Access Compliance Report

Public Rights-of-Way

Intersection ID: 2959	Main Street: HARBURN_FOREST_DR	Cross Street: TUNSTON_LN	Location: NE
ADA ID: DD1109AA6D86	Ramp Type: PerpDiag	Initial Pass/Fail: Fail	Overall Compliance: No
		Severity Score: 25

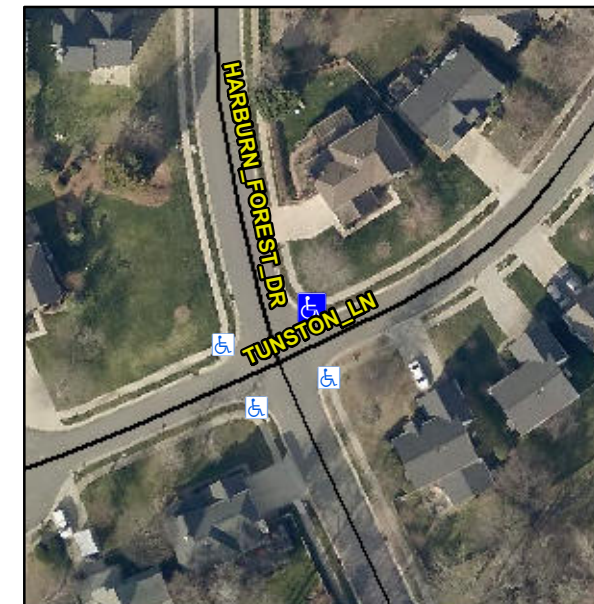
Not Found, R304.2.2, R304.5.3

Compliance	Description	Data	Compliance	Description	Data
N/A	Ramp Length (in)	48.0	No	Ramp Slope (%)	8.7
Yes	Ramp Width (in)	48.0	No	Ramp XSlope (%)	6.7
N/A	Flare Type LT	N/A	N/A	Flare Type RT	N/A
N/A	Flare Slope LT (%)	N/A	N/A	Flare Slope RT (%)	N/A
N/A	Flare Traversable LT?	N/A	N/A	Flare Traversable RT?	N/A
N/A	Landing Length (in)	N/A	N/A	DWS Provided?	N/A
N/A	Landing Width (in)	N/A	N/A	DWS Contrast?	N/A
N/A	Landing Slope (%)	N/A	N/A	DWS Length (in)	N/A
N/A	Landing X Slope (%)	N/A	N/A	DWS Full Width?	N/A
N/A	Landing Curb? (Y/N)	N/A	N/A	DWS Offset (in)	N/A
N/A	Shared Landing?	N/A			
N/A	Gutter Ponding?	N/A	N/A	Gutter Slope (%)	N/A
N/A	Gutter Lip Ht (in)	N/A	N/A	Gutter X Slope (%)	N/A
N/A	Painted X Walk1?	No	N/A	Painted X Walk2?	No
	X Walk 1 Direction	To W		X Walk 2 Direction	To S
N/A	X Walk 1 Width (in)	N/A	N/A	X Walk 2 Width (in)	N/A
	X Walk 1 Slope (%)	6.0		X Walk 2 Slope (%)	2.6
	X Walk 1 X Slope (%)	4.8		X Walk 2 X Slope (%)	7.0

Remove & Replace Curb Ramp With Two New Directional Ramps or Equivalent.
